**HISTORIC PRESERVATION BOARD STAFF REPORT**

**Sundy Village**

Meeting	File No.	Application Type
September 4, 2024	2024-162	Certificate of Appropriateness and Master Sign Program

The item before the Board is consideration of establishing a Master Sign Program (2024-162) for the development known as **Sundy Village within the Old School Square Historic District.**

**Wall signs (17) – Tenant Name**

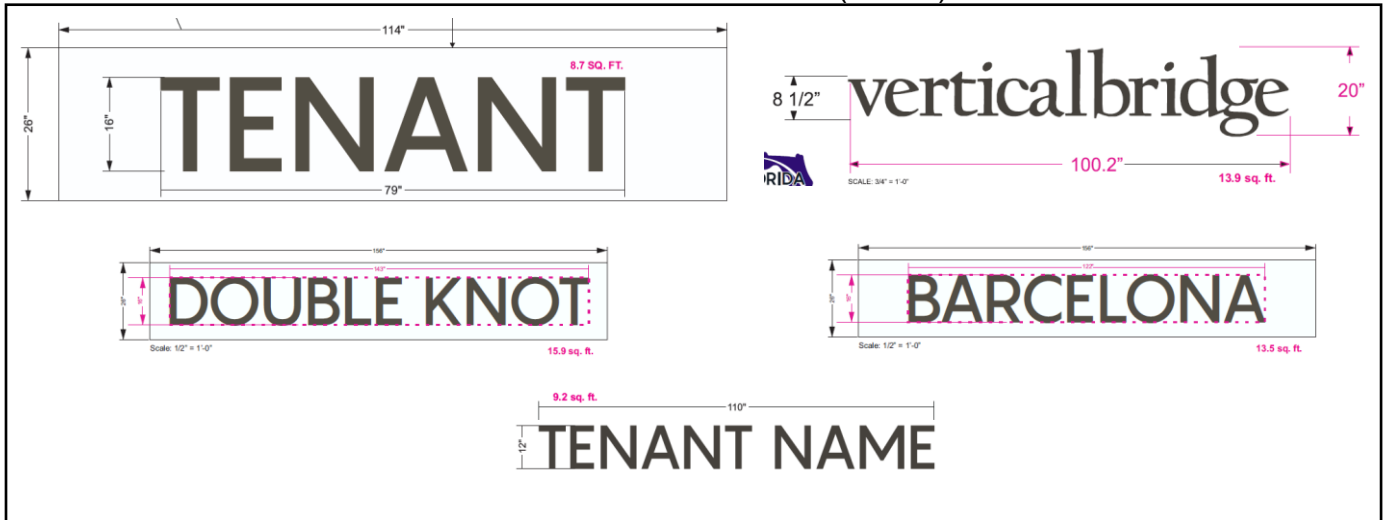
Another concern are the proposed tenant signs at the northwest and northeast corners of Buildings 1, 2, & 3, facing W. Atlantic Avenue. The tenant signage eliminates porch railings, an architectural element integral to the design of the structure. Additionally, the signage does not appear to be compatible with the historic district (see image to right). An alternative for such signage would be to place tenant signage within the civic open space area rather than eliminating the porch railing architectural details.

There are concerns with the proposed materials and design of signs associated with the historic structures as well as tenant signs on the front of Buildings 1, 2, & 3 (facing W. Atlantic Avenue). There is also concern, regarding the location of a wayfinding sign (W5), which is situated outside of the property lines at the corner of SW 1<sup>st</sup> Avenue and W. Atlantic Avenue (northwest corner of the site). This sign is between the sidewalk and the property line, and while it is not within any site visibility triangles, signs specific to the site are to remain within the property.

**Projecting Signs (21) – Tenant Name**

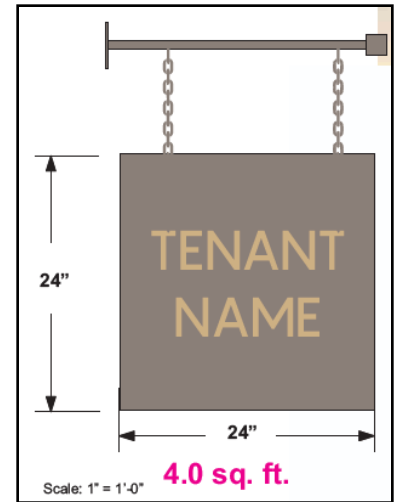
Since a portion of the site is within the OSSHAD with CBD Overlay, Section 2(b) above is applicable. There are a series of projecting signs placed on the face of the arcade of Buildings 1, 2, & 3 and may not extend from the exterior face of an arcade. An added site plan technical item is that the proposed projecting signs be changed to be compliant with the LDRs.

**Free – Standing Monument Signs (11) (10 – Historic Restaurant, and 1 - Site Name)**

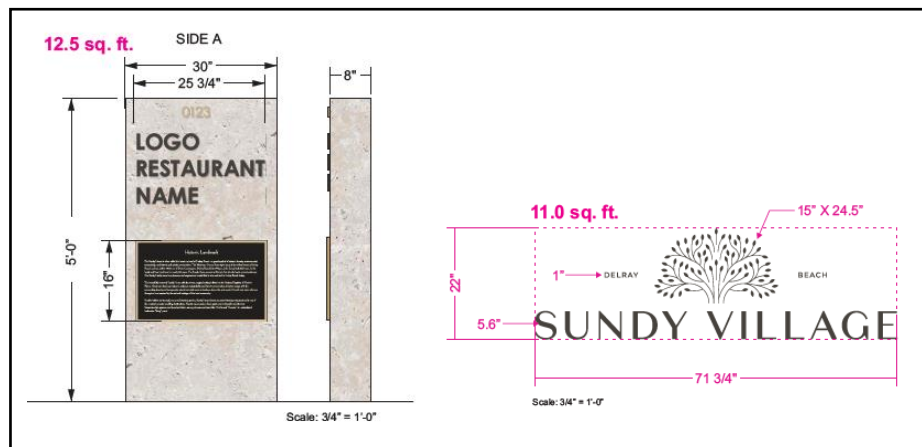
There are concerns with the material, type, and size of proposed signs in association with the historic structures along S. Swinton Avenue. The proposal includes ten 5' tall stone, ground mounted, monument signs to be located in the front and rear of the historic structures. The Design Guidelines state that **sign material should be compatible with the construction materials of the buildings** and the buildings are either wood frame or stucco exteriors. Additionally, these structures were originally constructed as residences and later converted for commercial use. The recommended approach for the design of proposed signage for structures that were converted from residential use is to **incorporate materials from the structure into the design of the sign (for example a wood sign would be an appropriate choice for a wood frame structure)**. Further, the use of compatible signage would aid in communicating the historic nature of the structures where the site is largely comprised of new construction.

While the stone monument signs might be considered consistent with the overall sign proposal across the Sundy Village site, there are concerns that these 10 signs may not meet the design and historic requirements of the Design Guidelines. It is noted that city staff provided this guidance to the applicant

prior to the board meeting and encouraged the use of signage that would be historically compatible with the existing historic structures.

The proposed signage adjacent to the historic structures includes the use of stone monument signs where the historic structures are wood frame with wood siding or stucco exteriors. The proposed signs represent the introduction of a different architectural style and material, which may not be considered appropriate for the Frame Vernacular and Bungalow architectural styles of the historic structures. Compliance with this standard can be made by utilizing signage styles with appropriate materials to be visually compatible with the style of the historic structures.
